REMARKS

At the outset, the Examiner is thanked for the thorough review and consideration of the present application. The Office Action dated July 21, 2003, has been reviewed and its contents carefully reviewed. Claims 1-38 are currently pending in the present application, claims 10-14, 19-21, 27-31, and 35 having been withdrawn from consideration in view of the Election of Species Requirement dated March 26, 2003. Reexamination and reconsideration of the pending claims is respectfully requested.

FIG. 11A

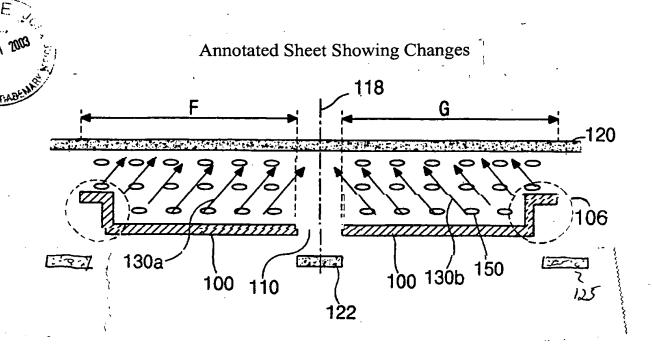
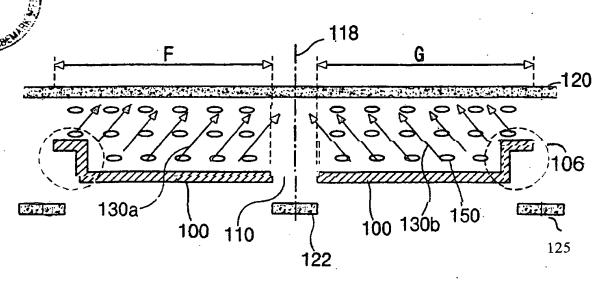
In the Office Action, the drawings are objected to under 37 C.F.R. § 1.83(a) as not showing every feature of the invention specified in the claims. Applicant hereby provides new Figures 11A and 11B to show the features recited by claim 5 of the present application. Both a replacement sheet and annotated sheet showing changes is included herewith.
